APPLICATION NO.	FILING DATE	FIRST NAMED INVENTOR	ATTORNEY DOCKET NO.	CONFIRMATION NO.
10/673,536	09/29/2003	Matthew G. Goulet	29641/39623	1848
4743	7590	11/08/2004		
MARSHALL, GERSTEIN & BORUN LLP 6300 SEARS TOWER 233 S. WACKER DRIVE CHICAGO, IL 60606			EXAMINER NGUYEN, GEORGE BINH MINH	
			ART UNIT 3723	PAPER NUMBER

Office Action Summary

DETAILED ACTION

With reference to Figure 1, col. 3, lines 1-22, Hutchins discloses the claimed invention.

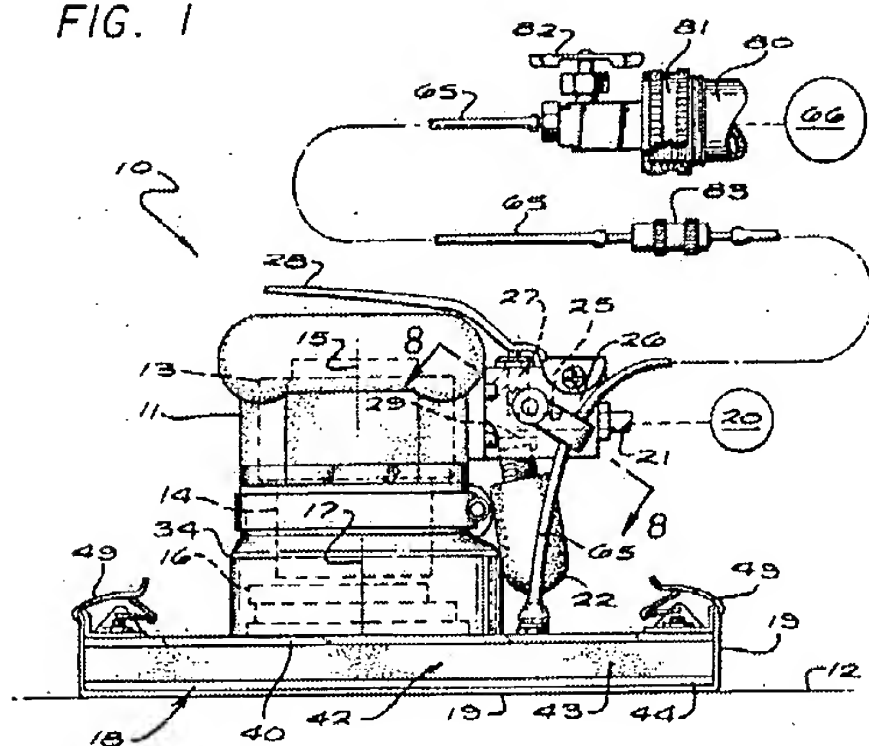
5. Claims 1-4, and 6-7 are rejected under 35 U.S.C. 102(b) as being anticipated by Hutchins'5,022,190.

Please note that spring clip 49 has a cam surface at the end of pivot arm. The end cam surface applies a compressive force against the base 42 to hold the sand paper 19 onto the base.
